**Planning Permission**

**Title:** Revisions  
**Garage door**  
**Scale:** 1:100  
**Project:** Sunbury, Fitzroy Park  
**Applicant:** Steve Barber & Sue Barber  
**Date:** 03.02.24

**31.24. A**

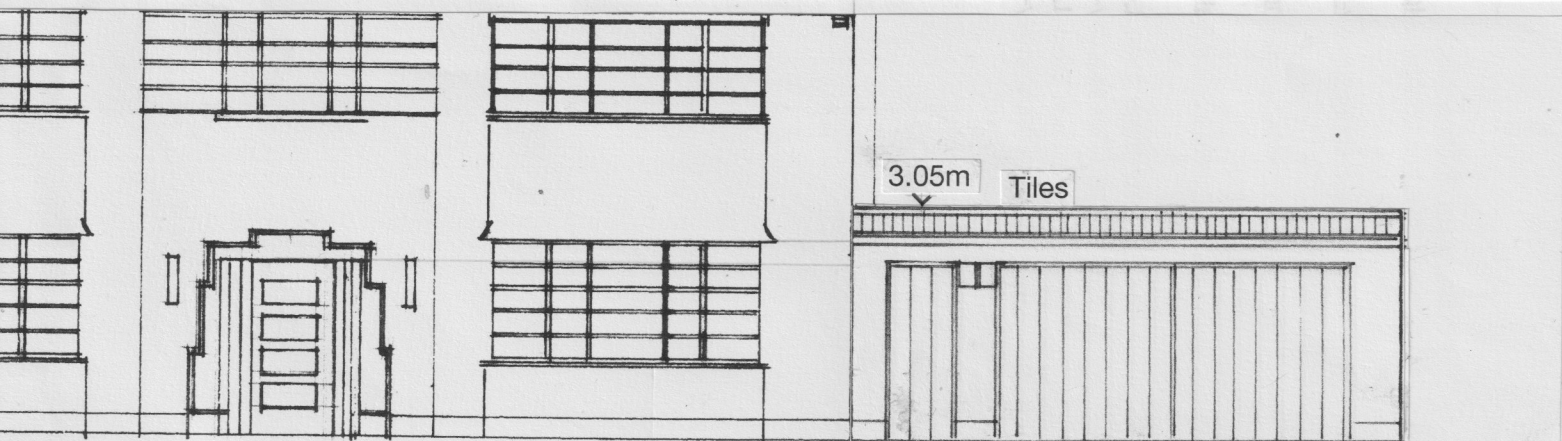
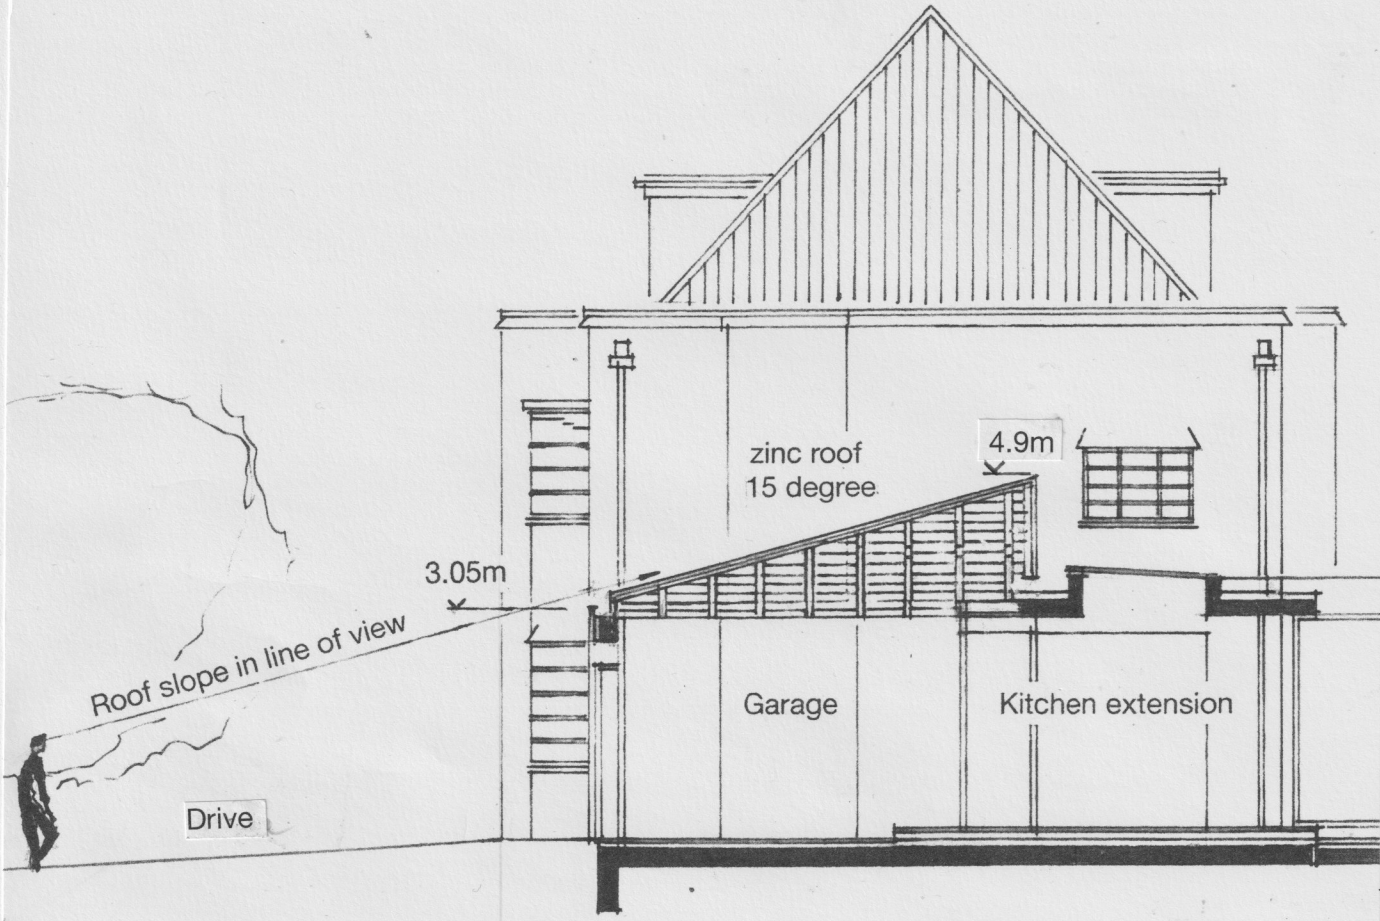
**To be demolished:**  
Wall to garage area

Reasons for the demolition of the existing garage wall and door:

The demolition work of the existing rear extensions and garage require heavy machinery. The existing opening of the garage door is neither wide nor high enough to allow the passage of the machines. Therefore the wall will have to be demolished and rebuilt after finalising the work at the rear.

The procedure for the work will be as follows:

1. Removal of the row of tiles at the top of the existing wall and storage for reuse.
2. Demolition of the wall.
3. Execution of the rear demolition work. Erection of the structure for the rear and side extension.
4. Rebuilding the garage wall according to the new requirements, but similar in appearance to the existing:
  - a. Same position, same render and colour of the wall.
  - b. Reinstating of the row of top tiles.
  - c. New wider and slightly higher garage door, in similar appearance to the existing (vertical cladding and colour).

Title: **Revisions roof slope garage** Drwg.No **31.25. A**  
**Garage roof slope 1**

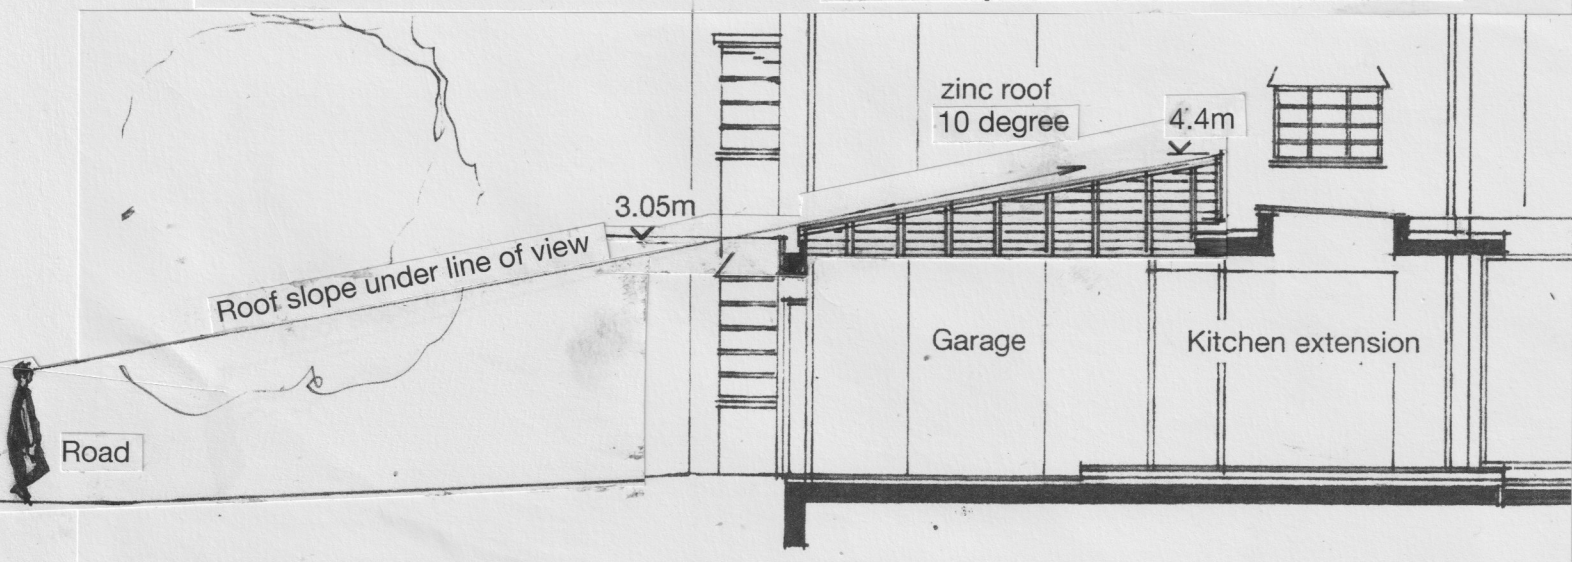
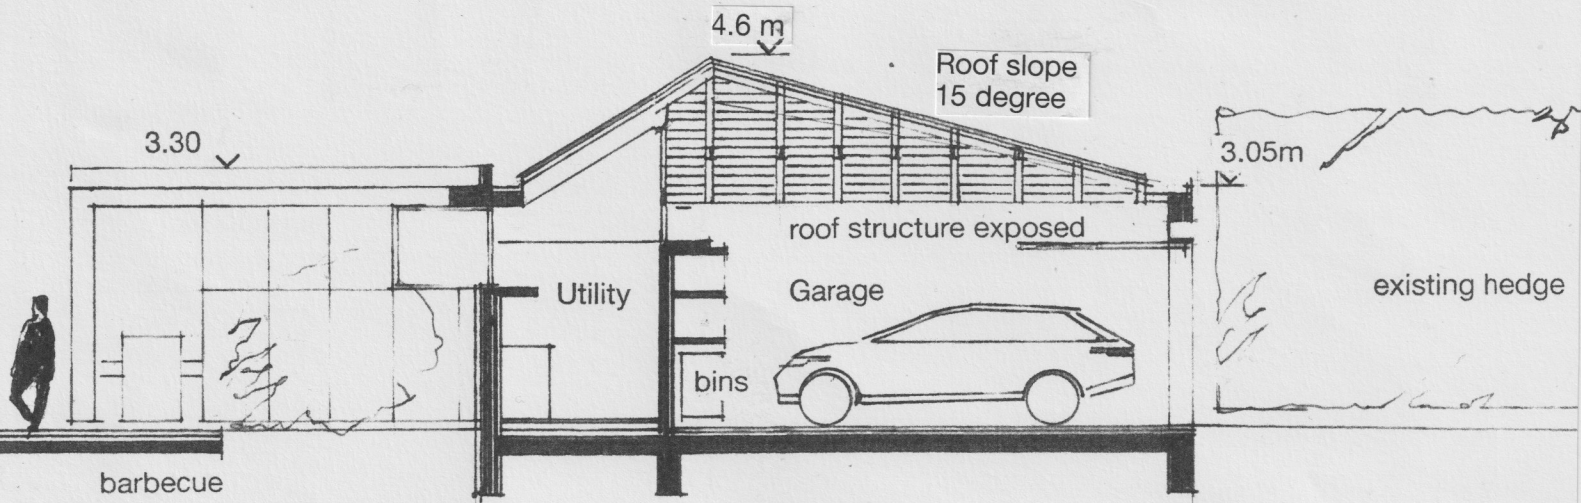
**South elevation of original application**

**South elevation revision**

**31.26. A**

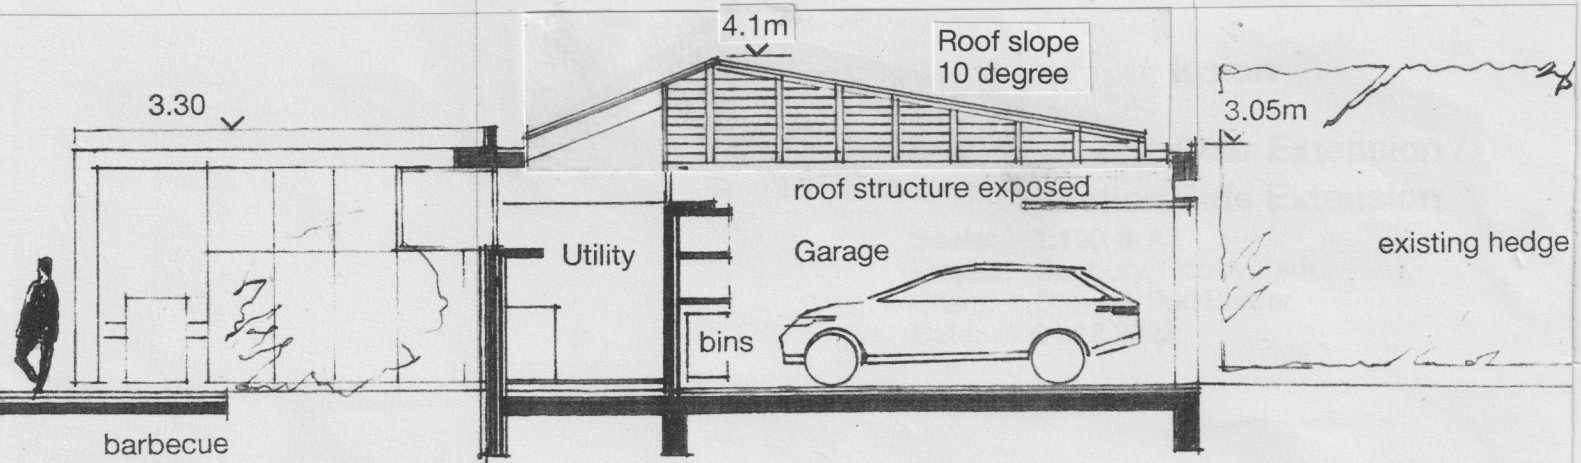
**Side extension of original application**

**Side extension revision**
